STONE AND WEBSTER MICHIGAN, INC.
P.O. BOX 1963, MIDLAND, MICHIGAN 48640

STONE & WEBSTER CONSTRUCTION IMPLEMENTATION OVERVIEW MIDLAND NUCLEAR PLANT J.O. NO. 14509		ITEM NUMBER 072	HOLD POINT NUMBER _____
		<input type="checkbox"/> TRACKED ACTION ITEM	
		<input checked="" type="checkbox"/> TRACKED INFORMATION ITEM	
		<input type="checkbox"/> TRACKED RECOMMENDATION ITEM	
		<input type="checkbox"/> UNTRACKED ITEM	
REFERENCE(S) ANSI N45.2 Section 7		<input type="checkbox"/> HOLD POINT NOTIFICATION	
CONDITION DETAILS The following approved B&W NDE procedures lack consistency in specifying the procedure, page and revision number as applicable. A) Procedure NDE PQ-RT - 200 Δ consist of 3 pages Page 1 of 3 reads: NDE-PQ-RT-200 Page 1 of 3 Revision 1 Page 2 of 3 reads: 9T-RT-200 Page 2 of 3 No Revision specified Page 3 of 3 reads: 9T-RT-200 Page 3 of 3 No Revision specified B) Procedure NDE-PQ-RT-201 Δ consist of 3 pages Pages 2 of 3 and 3 of 3 lack procedure number and revision. C) Procedure NDE-PQ-RT-202 Δ consist of two pages Pages 1 & 2 lack page number What action is being taken to resolve the identified inconsistencies? <div style="float: right;"> (PAGE YES NO'S) <input checked="" typ

Number NDE-PQ-RT-200, Rev. 1

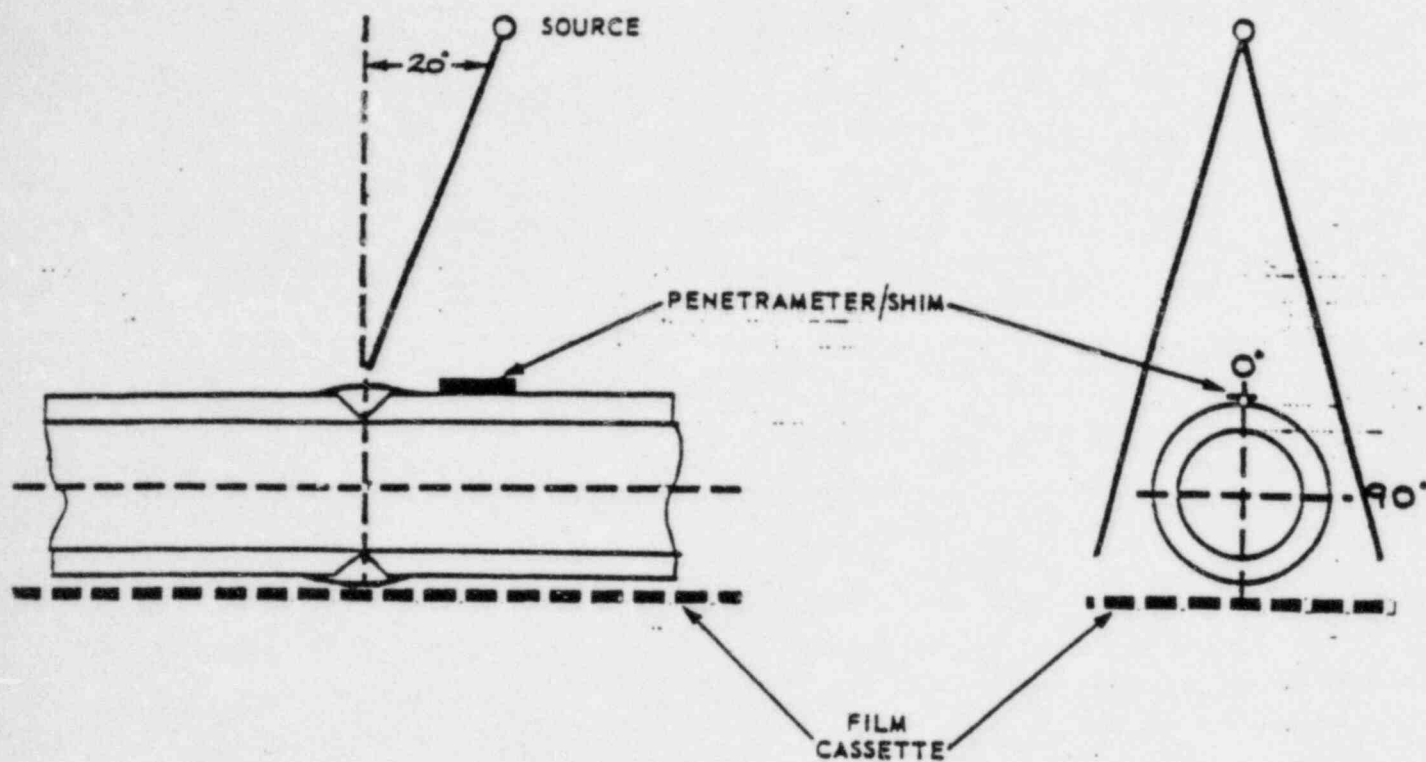
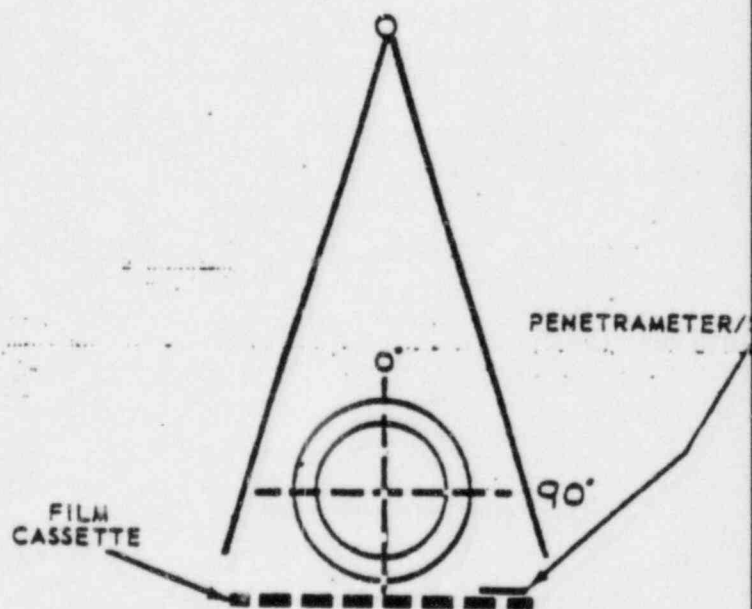
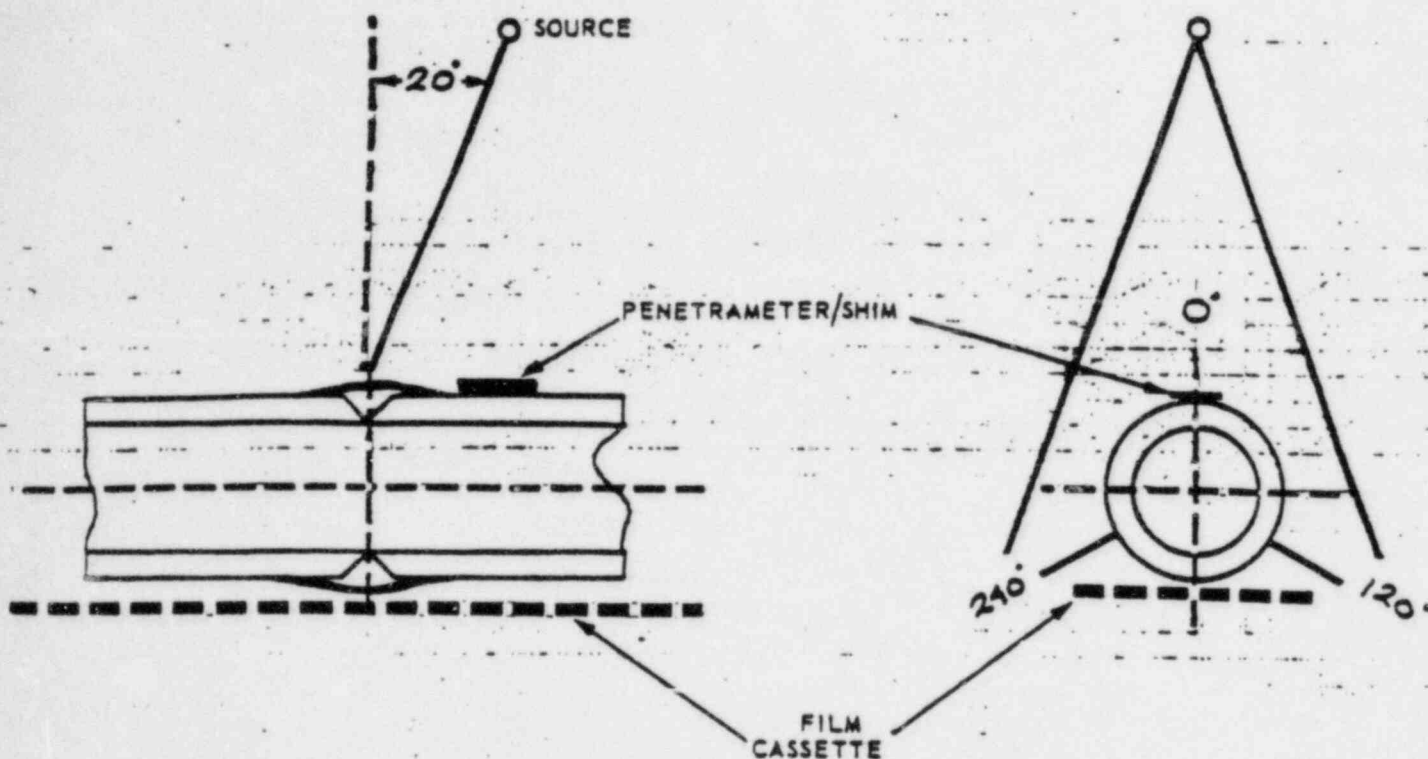
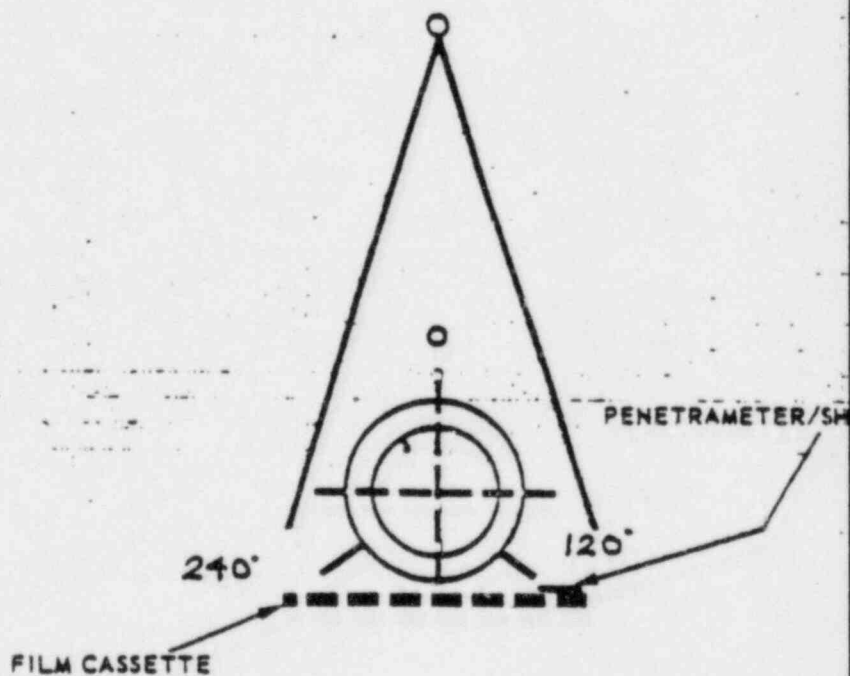
ATTACHMENTS			
DATE RESPONSE REQ'D. 4-23-84	INITIATOR/DATE <i>Ronald E. Horine 04-11-84</i>	INITIATION APPROVED/DATE <i>Not Acting for DEK 4-11-84</i>	
RESPONSE (SEE NOTE) Attached Bechtel Letter BCCC-9287 dated April 30, 1984 has been reviewed by CPCo SMO and determined to provide a complete response to this item. *(Follow up closeout verification) On 5-30-84, the following was verified and found satisfactory: A) NDE-PQ-RT-200, Rev 1, Page 2 of 3 & Page 3 of 3 have been annotated with NDE-PQ-RT-200, Rev 1. B) NDE-PQ-RT-201, Rev 1, Page 2 of 3 & Page 3 of 3 have been annotated with NDE-PQ-RT-201, Rev 1. C) NDE-PQ-RT-202, Rev 0, Pages 1 & 2 have been numbered. The above verification as viewed in B&W controlled QC manual no. 22 CPCo. <div style="float: right;"> (PAGE YES NO'S) <input checked="" type="checkbox"/> YES 9 <input type="checkbox"/> NO </div>			
ATTACHMENTS			
EST. CORRECTIVE ACTION COMPLETION DATE <i>NA</i>	RESPONDENT <i>MI Boudel</i>	TITLE <i>Hest. Const. Supt.</i>	DATE <i>5/9/84</i>

Procedure NDE-PQ-RT-200 Revision 1, Page 2 of 3 and Page 3 of 3, have been annotated with PQ-RT-200 Revision 1.
